# Access Compliance Report

## Public Rights-of-Way

Intersection ID: 7091	Main Street: BROOKSHIRE_BV	Cross Street: HOVIS_RD	Location:	E
ADA ID: 914C92E39BE4	Ramp Type: Perp	Initial Pass/Fail: Fail	Overall Compliance: No	Severity Score: 8.75
Codes/Mitigation Info/Possible Solution		Field Measurements/Component Compliance

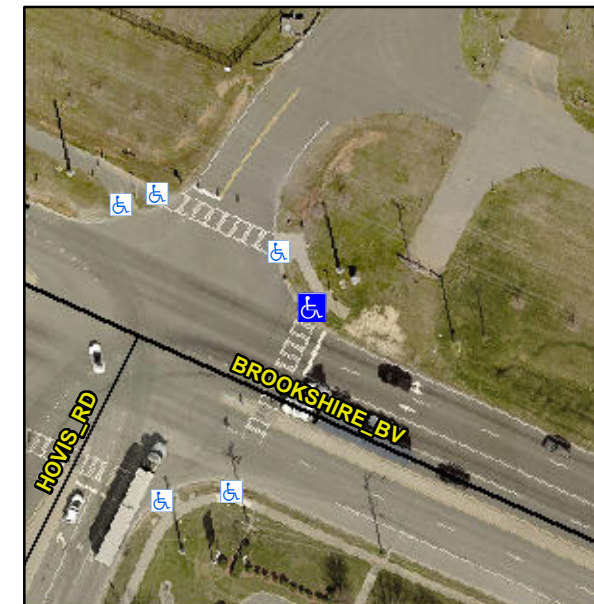
Compliance	Description	Data	Compliance	Description	Data
N/A	Ramp Length (in)	96.0	Yes	Ramp Slope (%)	8.1
No	Ramp Width (in)	47.0	Yes	Ramp XSlope (%)	0.2
N/A	Flare Type LT	N/A	N/A	Flare Type RT	N/A
N/A	Flare Slope LT (%)	N/A	N/A	Flare Slope RT (%)	N/A
N/A	Flare Traversable LT?	N/A	N/A	Flare Traversable RT?	N/A
N/A	Landing Length (in)	N/A	N/A	DWS Provided?	N/A
N/A	Landing Width (in)	N/A	N/A	DWS Contrast?	N/A
N/A	Landing Slope (%)	N/A	N/A	DWS Length (in)	N/A
N/A	Landing X Slope (%)	N/A	N/A	DWS Full Width?	N/A
N/A	Landing Curb? (Y/N)	N/A	N/A	DWS Offset (in)	N/A
N/A	Shared Landing?	N/A			
N/A	Gutter Ponding?	N/A	N/A	Gutter Slope (%)	N/A
N/A	Gutter Lip Ht (in)	N/A	N/A	Gutter X Slope (%)	N/A
N/A	Painted X Walk1?	Yes	N/A	Painted X Walk2?	N/A
	X Walk 1 Direction	To SW		X Walk 2 Direction	N/A
N/A	X Walk 1 Width (in)	112.0	N/A	X Walk 2 Width (in)	N/A
	X Walk 1 Slope (%)	0.1		X Walk 2 Slope (%)	N/A
	X Walk 1 X Slope (%)	2.3		X Walk 2 X Slope (%)	N/A

**Remove & Replace Entire Ramp.**
